Axial de-scanning using remote focusing in the detection arm of light-sheet microscopy

Reviewers' comments:

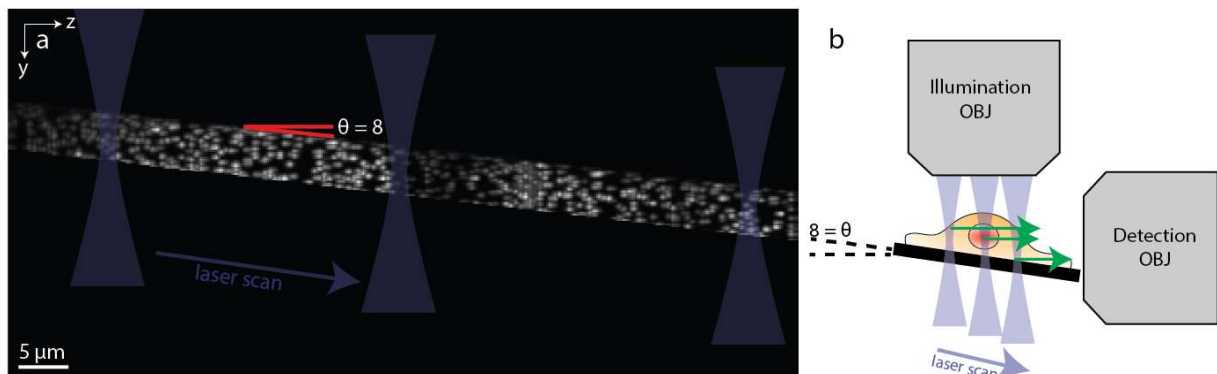
Dibaji et al. describe an optical method to incorporate remote focusing for Z-scanning into the collection arm of a fluorescence microscope. Standard remote focusing architectures rely on polarization to direct light to and from the remote focusing optics, meaning they would incur a 50% light loss in the (unpolarized) collection arm of a fluorescence microscope. The method described here is unique in that there is no polarization-induced light loss. Compared to mechanical Z-scanning methods (e.g., translating the objective lens or sample), this method allows for faster scanning and does not require translating the sample. Compared to optical methods (e.g., SLM / DM) this method can achieve larger scan ranges and reduced aberrations. The authors implement their approach in a light-sheet microscope, characterizing the optical performance (PSF) of the device and demonstrating live cell imaging.

I find this to be a very elegant technique. Through a clever arrangement of only two additional mirrors, the setup can recover all the light that would ordinarily be lost at the PBS in a conventional remote focusing setup. I agree that this technique should have broad applicability in a number of microscopy techniques and will be of interest to readers. We sincerely appreciate this comment and believe that this method can truly change how 3D volumetric imaging is done across many microscopy techniques. We sincerely thank the reviewer for commending the importance of our work. The manuscript is technically sound, and the concept is novel to my knowledge. However, I find various parts of the manuscript confusing and believe the clarity needs to be improved prior to publication. Several suggestions are below:

I am confused by the 8 deg angle mentioned in multiple places. I assume this is intentional (as opposed to a misalignment) – is this a geometric constraint needed to maintain an orthogonal light-sheet geometry while imaging cells on a coverslip? Similarly, why / how is the sheet translated in the y-direction during z-scanning? Can the authors explain this? Perhaps a diagram of the collection and illumination beams relative to the sample and coverslip would be helpful.

We agree with the reviewer that the “8-degree” information is confusing and sincerely apologize for not clarifying that in our manuscript. As it turns out we have two separate but independent places where 8-degree angles come into play: (1) the angle between the S and the P beam before the Obj2, and (2) the angle between the lightsheet translation and the Z-axis.

While the 8-degree angle between the S and P beam was a design requirement, the reviewer is correct in his/her assumption that the 8-degree angle between lightsheet translation and the Z-axis was a geometric constraint needed to maintain an orthogonal lightsheet geometry. This is because, to ensure that the detection light paths are not aberrated or hindered by the glass coverslip we tilted the coverslip slightly (by 8 degrees) while still trying to maximize the volume spanned by the lightsheet waist, as shown in Sup. Fig. 8. Therefore, we traversed the lightsheet waist to follow along the surface of the coverslip. This then required us to break the conjugation of the galvo and the illumination objective ever so slightly that we could get the lightsheet scanning volume orthogonal to the coverslip. As suggested, we have now clearly depicted this in our Supplementary Figure 8. [Line 465-469]
